**ONSITE SEWAGE DISPOSAL SYSTEM**

**PERMIT  
CONSTRUCTION**

PROPERTY ADDRESS: 14508 Edgewoods Way

SUBDIVISION: Edgewoods Farms

**TRENCH/DRAINFIELD DATA**

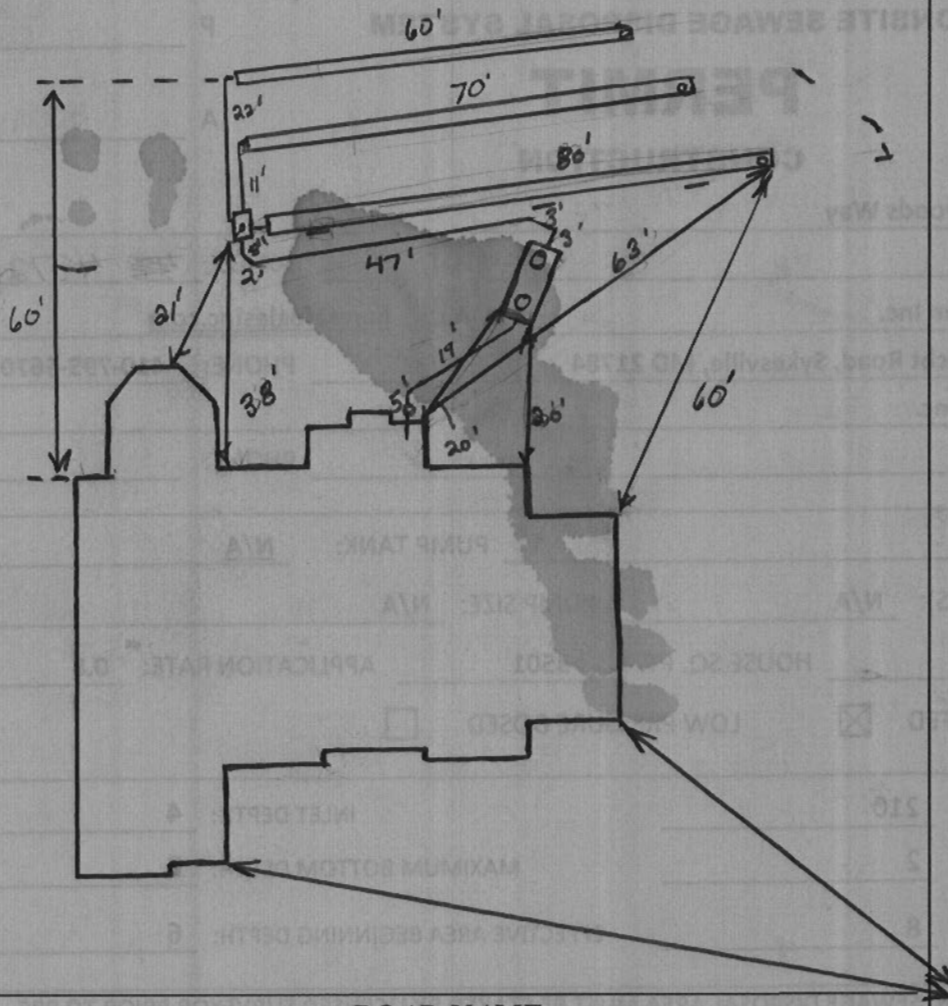
9/26/13 No File found in office. Generated file from perc notes and PC. listed as 4BR, Install Dbox top middle part of SRA, Install an 80, 70 and 60' trenches across top part of SRA running towards Lot 7. Keep tank 20' from dwelling. Must call in f/u inspection (KW)

9/30/13 Call received from contractor concerning sewer vent location not found (KW)  
 9/30/13 Site visit. Grades shot to adjust trenches. Tank must be set on right side of property due to sewer location out of house not as on approved BP plan. Keep trenches as per original layout. Keep tank 20' from house and 100' from well (KW) 9/30/13 (pm) Tank set. SHE

INSTALLATION: D box set. OK to continue (KW) 10/1/13 Top trench dug and stoned. 10/2/13 Trenches complete. need to verify Dbox level adjustment. OK to cover.

WALL CHECK  
 LOT #6  
**EDGEWOOD FARM**  
 IIRFR 4174 FOLIIO 436

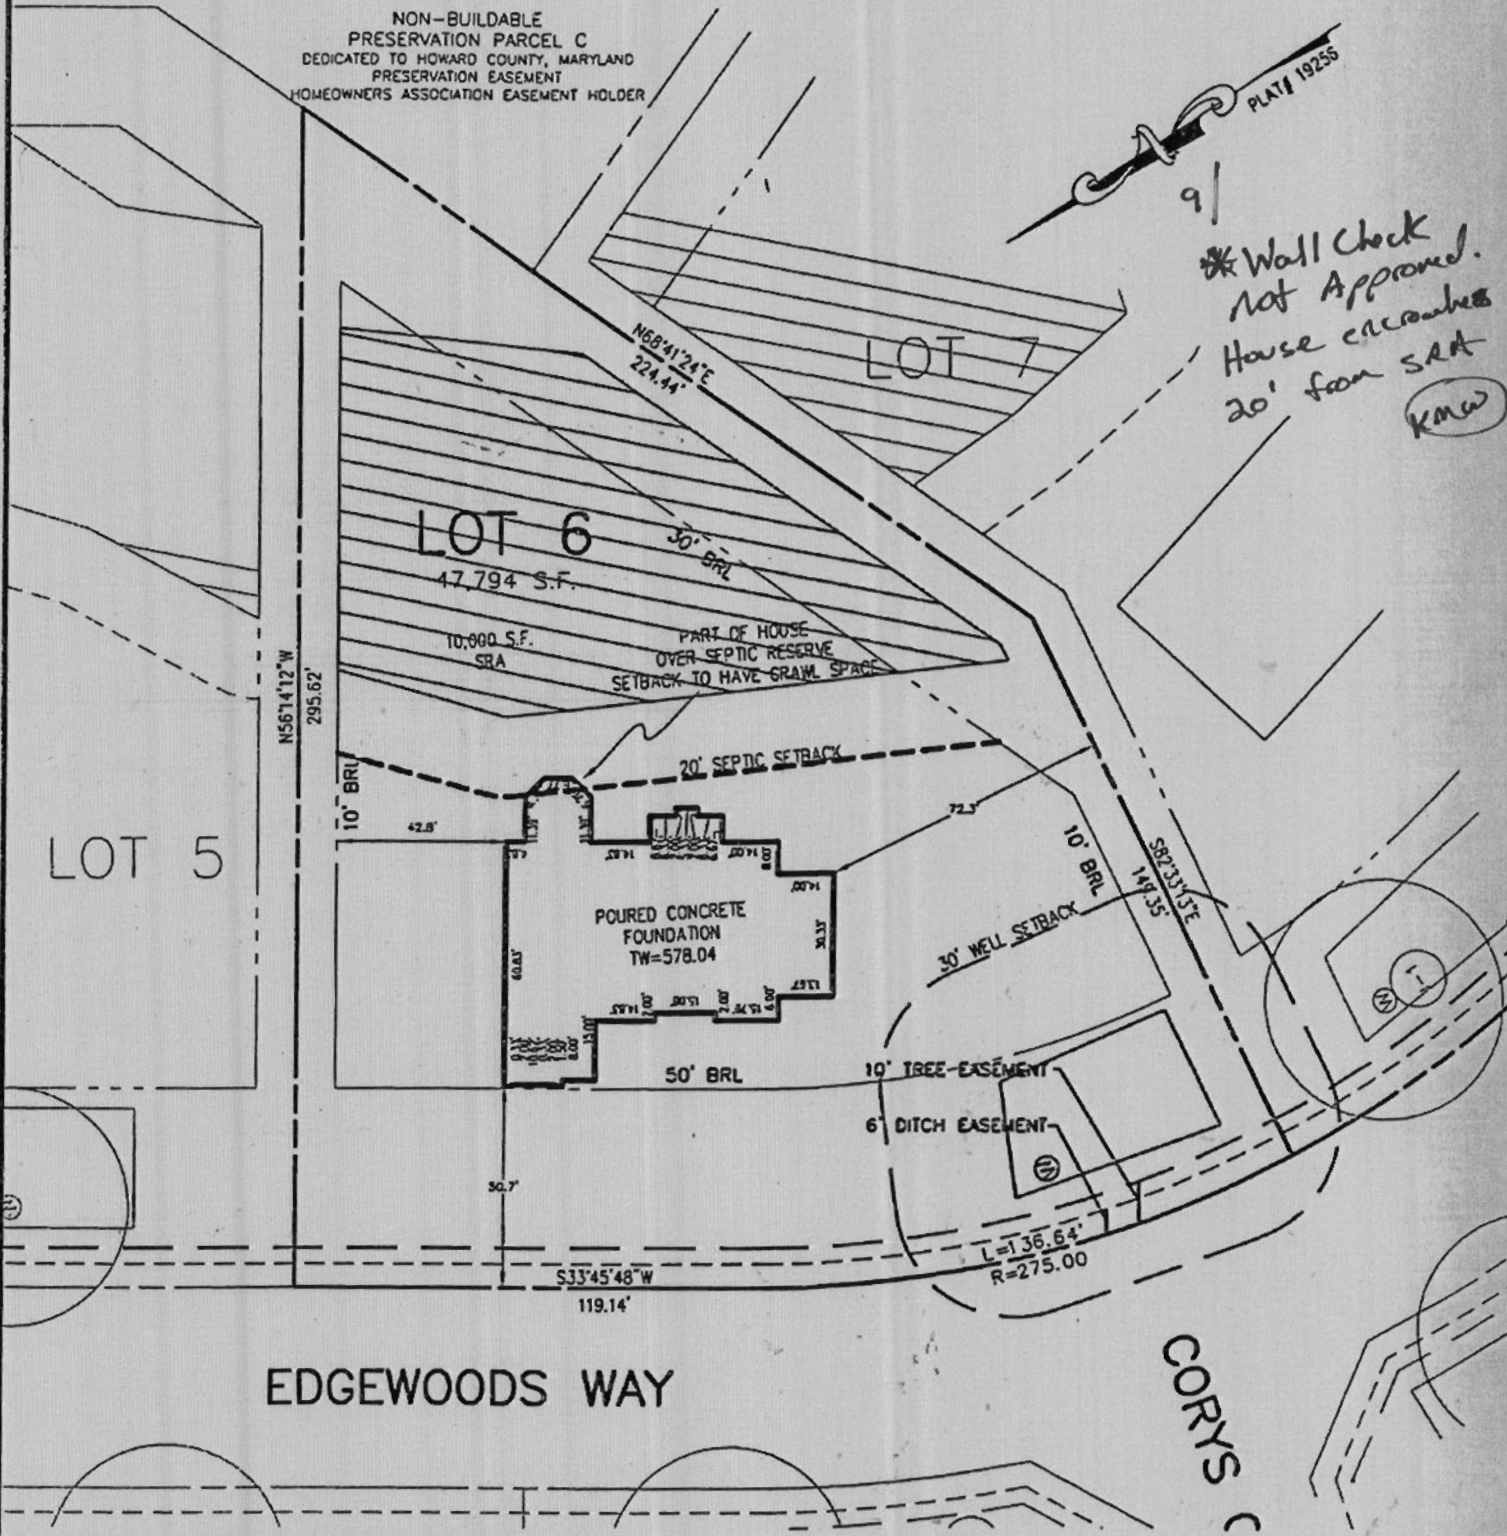
\*Wall Check  
 Not Approved.  
 House encroaches  
 20' from SRA  
 (KMW)
